Shek Pik submarine pipeline, Hong Kong water supply

Shek Pik dam

Mr C. D. Crosthwaite (Partner, Freeman, Fox & Partners) confined his remarks to the Paper on the submarine pipeline.

FIG. 42

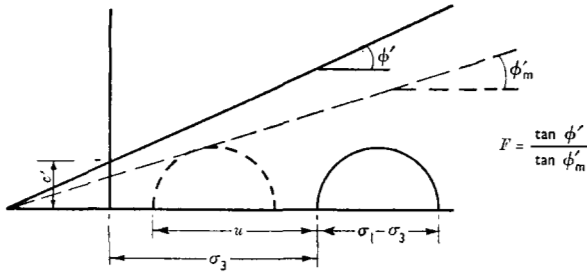
176. Bishop and Henkel⁶ described the constant effective stress-ratio test for \bar{B} and Fig. 42 was similar, the symbols used having the same meaning.

177. Fig. 42 could be described in trigonometrical terms by the equation:

Equation (2) was simply the statement of a property of a diagram such as Fig. 42 and depended upon no soils theory. However, comparison of equations (2) and (3) demonstrated the absence from (3) of a term involving $\Delta \phi'_m$ —in effect, changes in F associated no doubt with deformation of the soil. The quantity A , therefore, could not be taken as a constant coefficient, nor could the alternative coefficient B . This was obviously well known to the designers of Shek Pik dam, as demonstrated by their later tests, but perhaps it was not more generally appreciated. The foregoing explanation did not seem to have been published previously.

FIG. 43

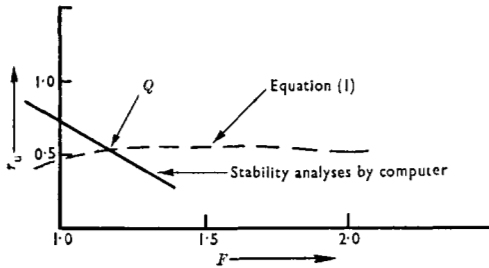
calculation for different F values then gave a curve of mutually compatible values of r_u and F . Next, a series of stability analyses was carried out in which a range of r_u values was used. F was again plotted against r_u . A typical plot for Kainji dam was shown in Fig. 43.

182. The two curves intersected in point Q which thus defined the only values of F and r_u which both satisfied the simple trigonometrical requirements of equation (1) (which was, after all, only a definition of the terms) and the stability analysis of a particular dam section, F referring to the worst case analysed. In other cases, of course, r_u could be higher or lower but could not then be critical.

293. If F (point Q, Fig. 43) for the trial design was found to be lower than required then the design would have to be changed and a new plot of F against r_u would have to be made. Thus, in the end, the same processes would have to be performed by both methods to achieve a pore pressure ratio prediction and the required factor of safety for a trial design. The actual triaxial test suggested by Mr Humphreys was somewhat easier to carry out since σ_3 was constant throughout the test. The method was satisfactory for the undrained condition but did not help in the prediction of pore pressure after partial consolidation, which was the fundamental problem in the use of effective stress analyses.

FIG. 44: LONGITUDINAL SECTION OF THE DAM ALONG THE CUT-OFF CENTRE LINE

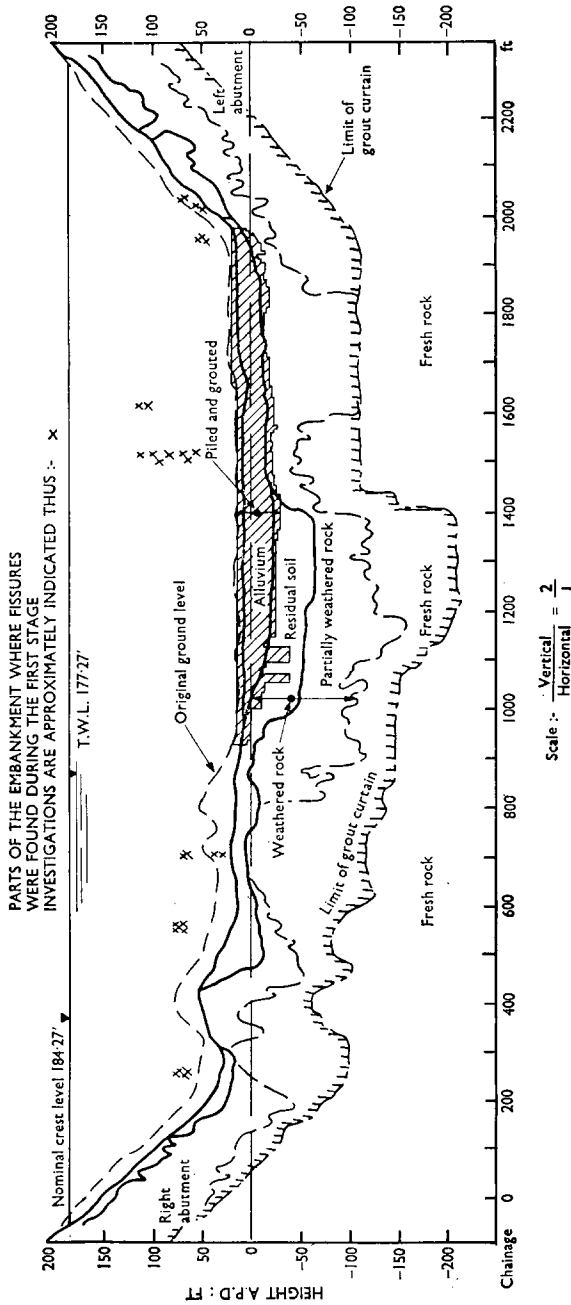
187. Fig. 44 was a longitudinal section of the dam showing the cracks discovered in the first stage investigation. The cluster of fissures at chainage 700 had been found in the first stage investigation which the Author described. That was where the trial trenches had been sunk. Two trenches had been dug there and cracks were found which had been filled with grout. There was also an almost horizontal crack, filled with sleeve grout. He had been unable to think of any explanation of the arrangement of the cracks.

FIG. 47

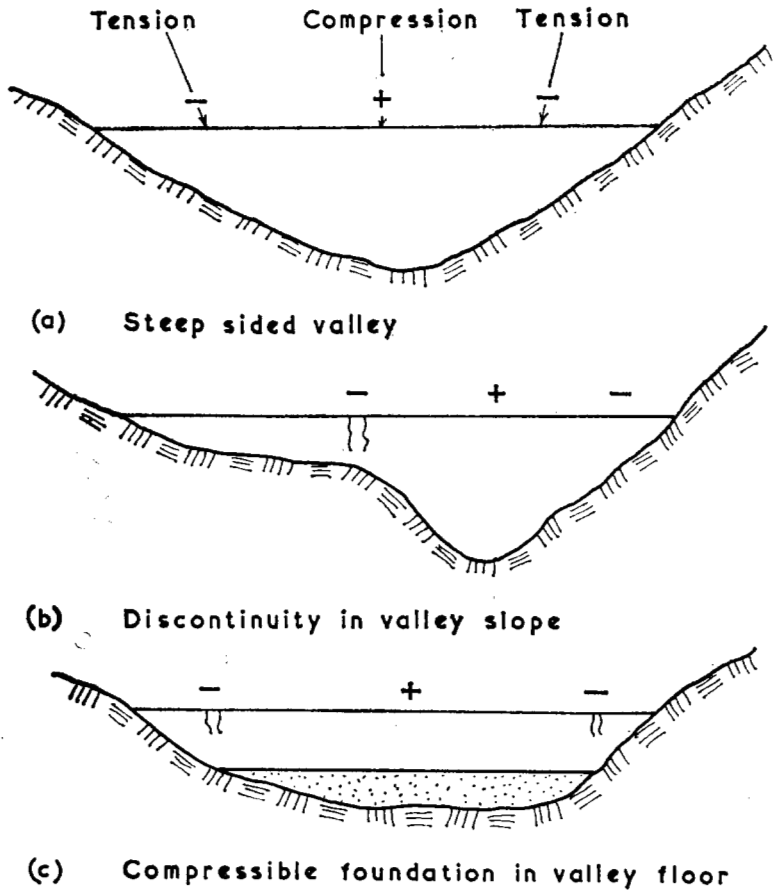
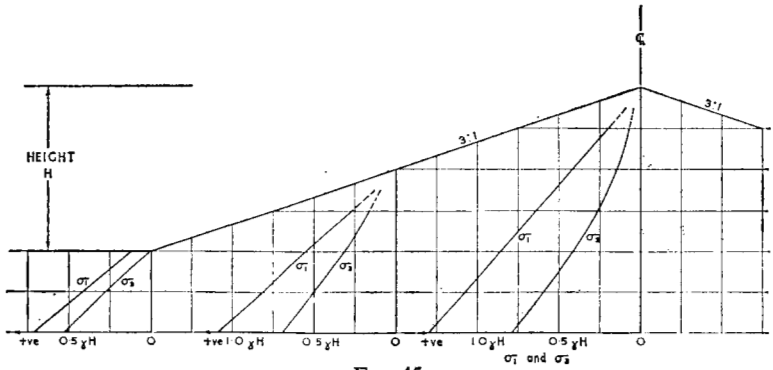
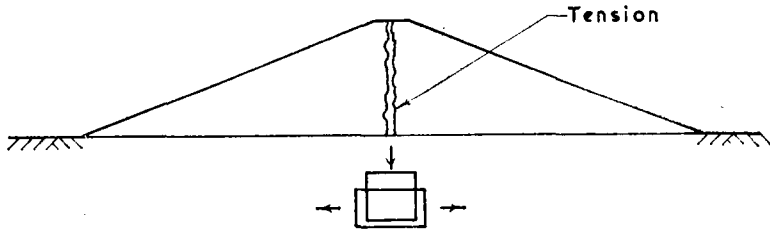
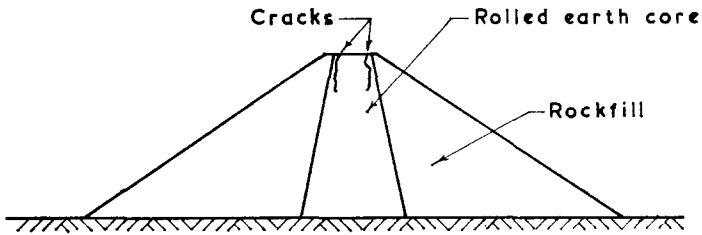
202. Longitudinal cracks (Fig. 47(a)) occurred in general where the foundation was more compressible than the fill and the foundation under undrained conditions yielded laterally. The tendency to lateral spread in the foundation caused vertical cracks to occur at or near the centre of the dam. A dramatic example of this had occurred after the 1953 floods on the Kent coast in a low bank of rolled chalk on the

203. Longitudinal cracks had also occurred in at least two dams due to the shell of rock fill or gravel being more compressible than the rolled earth core (Fig. 47(b)).

FIG. 48

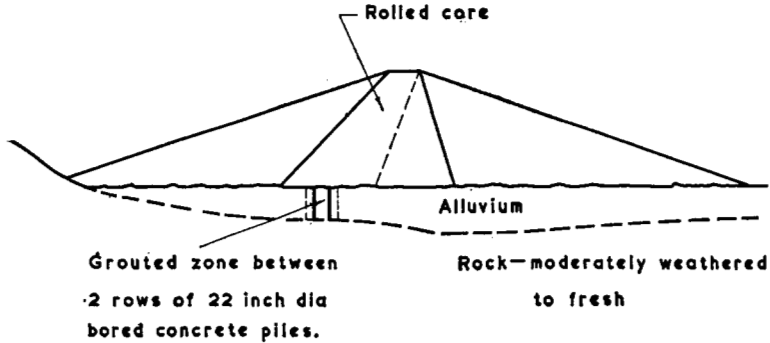
207. Much of the cracking, however, had occurred in fill placed in the centre of the valley after the grouting had been completed. The section in Fig. 48 showed that the core rested partly on grouted alluvium between two rows of 22 in. dia. bored concrete pile walls and partly on ungrouted compressible alluvium on each side. This gave a discontinuity: the alluvium directly under the centre line settled about 1 ft, almost all of this occurring during construction—there had been very little afterwards. This marked discontinuity in vertical strain might well have resulted in cracking of the core during placement under the added weight of each layer. The small subsequent settlement would explain why no surface cracking had occurred.

FIG. 49: SHEK PIK DAM SURFACE SETTLEMENT

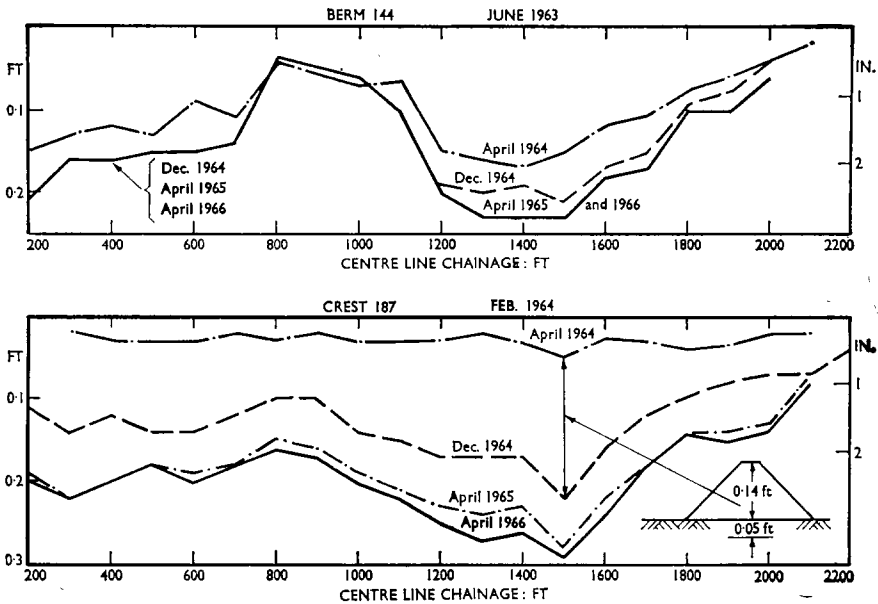
289. Following the filling of the reservoir, the settlement of the foundation had been found to be negligible. The compression of the fill under the berm at level 144 ft had been negligible but the settlement of the crest had reached 0.2 ft at chainage 1470. The cross-arm apparatus at this point had shown that the settlement was the result of compression of the core of the dam in the zone between levels 80 ft and 110 ft where the cracks had been most frequent and in which the largest quantities of test water and grout had been injected (see Fig. 49).

FIG. 50: CROSS SECTIONS THROUGH THE CORE OF THE SHEK PIK DAM

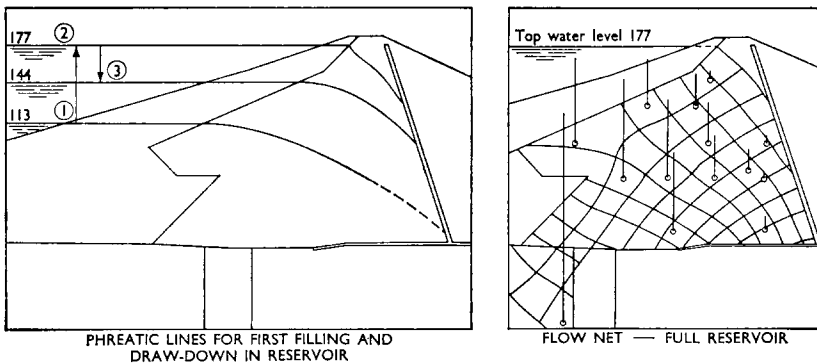
290. The progressive saturation of the core had been observed from readings of piezometers and standpipes. The simple flow net, which was shown in Fig. 50, had

been derived from the observations. The rate of saturation had been faster than would have been expected from a soil of low permeability and could be due to a network of small cracks remaining in the core. From the flow net it could be deduced that the permeability was fairly uniform.
